| RE: Recall Campaign Launch Notification Replace Main Fuse Box(es) MY23-24 C-Class, CLE, E-Class, EQE, EQE SUV, EQS, EQS SUV, GLC, S-Class, and SL (206, 214, 223, 232, 236, 254, 294, 295, 296 and 297 platform) | DATE: March 21, 2024 |

Recall Campaign Bulletin

Campaign No. 2024030008, March 2024

Revision C: February 28, 2025

Figure 3, Interior prefuse box cover, shown on model 206

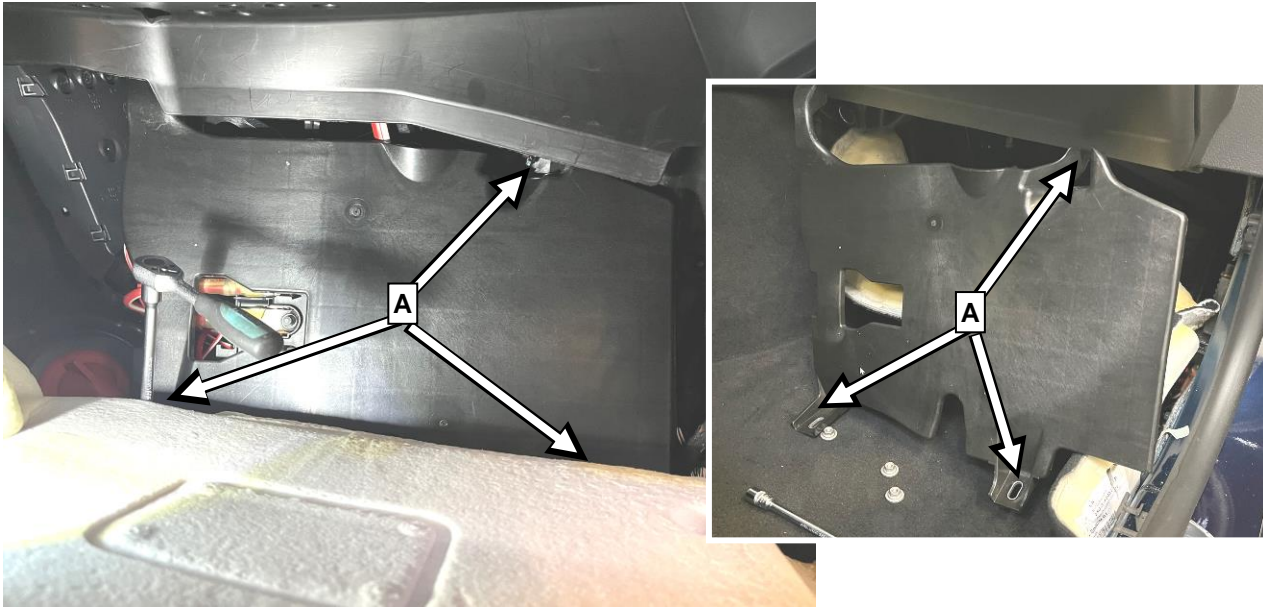
3. Unscrew nuts (**Figure 3, A**) of interior prefuse box cover and remove the cover.

Figure 4, Support bracket (A), covering prefuse box (B), shown on model 232

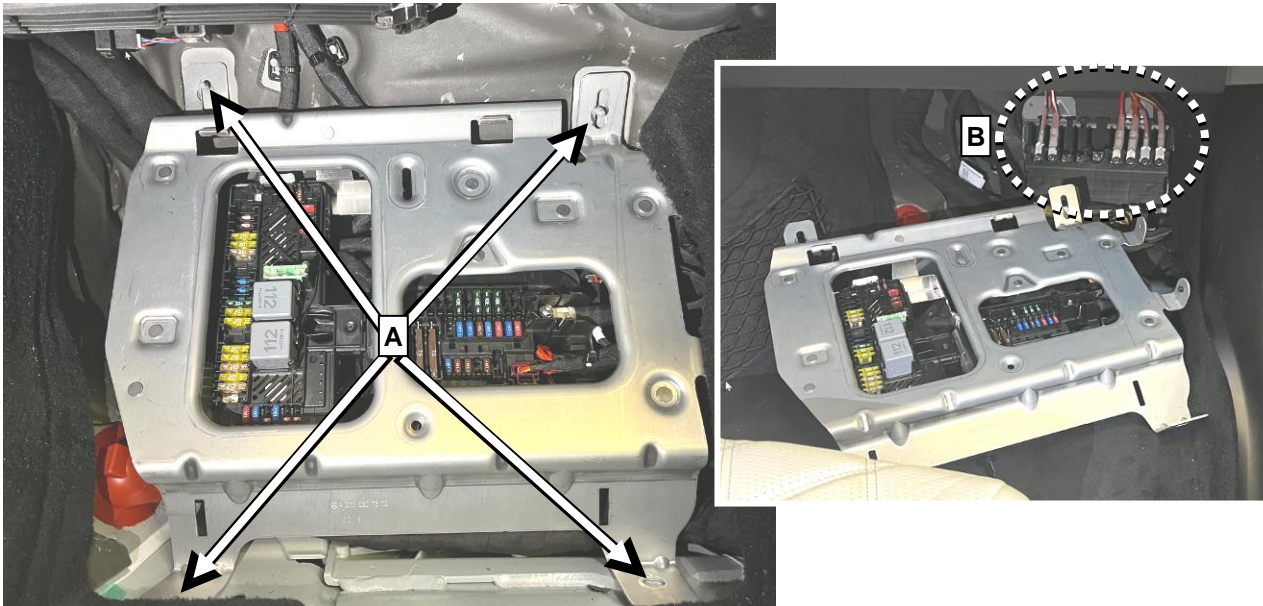
i For model 232: Unscrew fuse box holder support (**Figure 4, A**) covering prefuse box (**Figure 4, B**), place to one side keeping electrical lines connected.

Figure 5

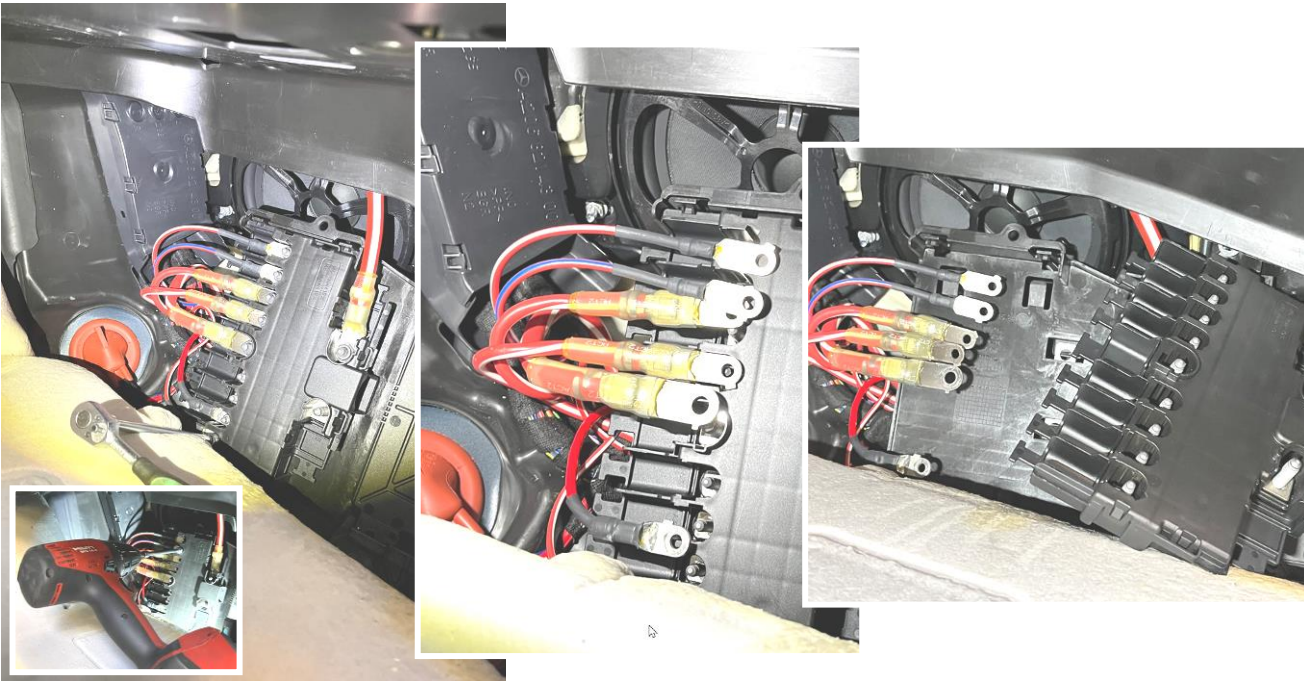
4. Replace **interior** compartment prefuse box (**F150/2**).

i **Mounting nuts must be reused.**

Nm **M6** nut, positive line to vehicle interior prefuse box: **8 Nm**.

Nm **M8** nut, positive line to vehicle interior prefuse box: **16 Nm**.

i Connections of the electrical lines are shape-coded to match the prefuse box and cannot be mixed up.

Figure 6

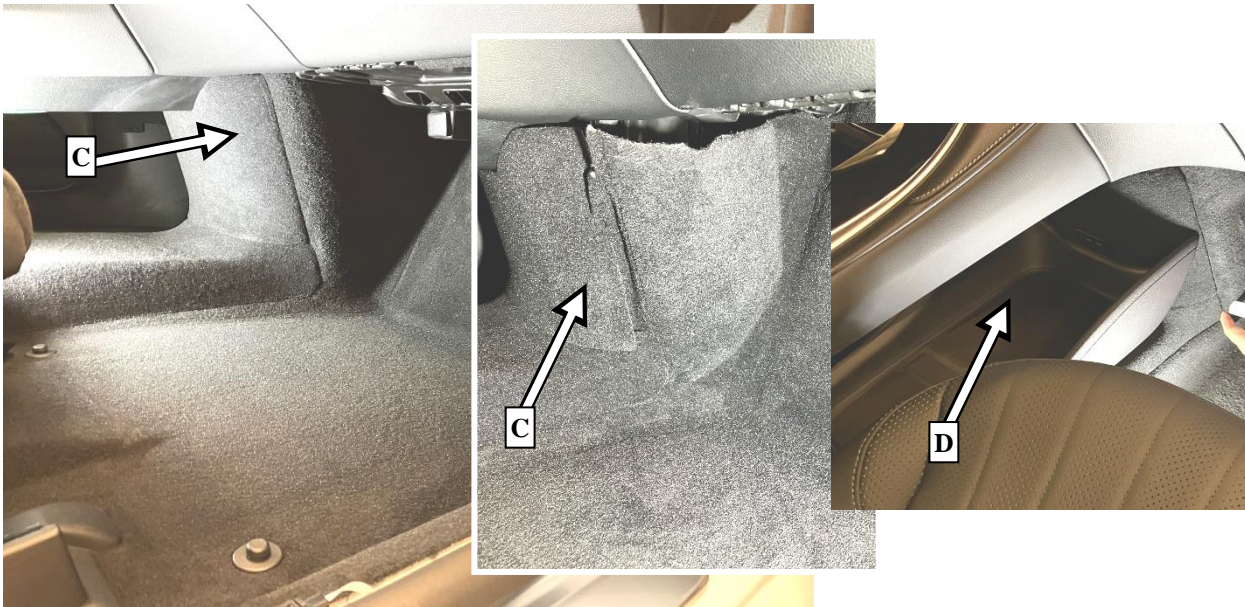
i To make it easier to fold back the floor covering, the trim (Figure 6, C) and the stowage tray (Figure 6, D) in front of the center console must be partially removed.

i To make it easier to fold back the floor covering, the trim (Figure 6, C) and the stowage tray (Figure 6, D) in front of the center console must be partially removed (see Work Procedure B).

Figure 8

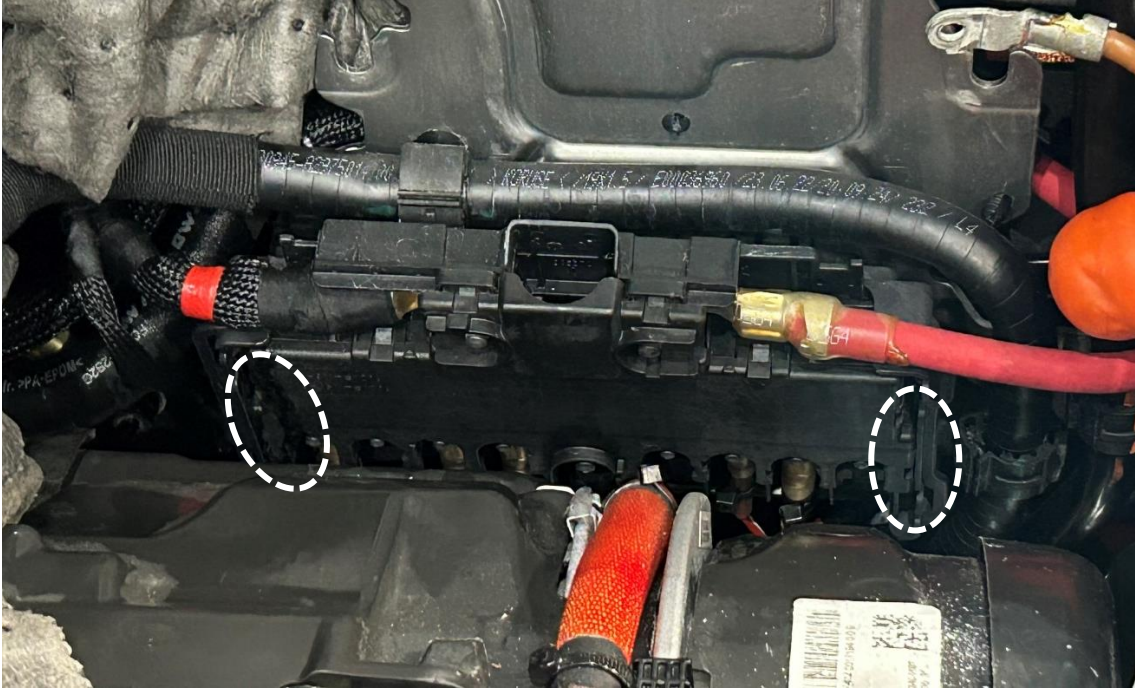
NOTE: For AR54.15-P-1330EQS **Step 5**; disconnect electrical connections first, then unclip from bracket (**Figure 8**).
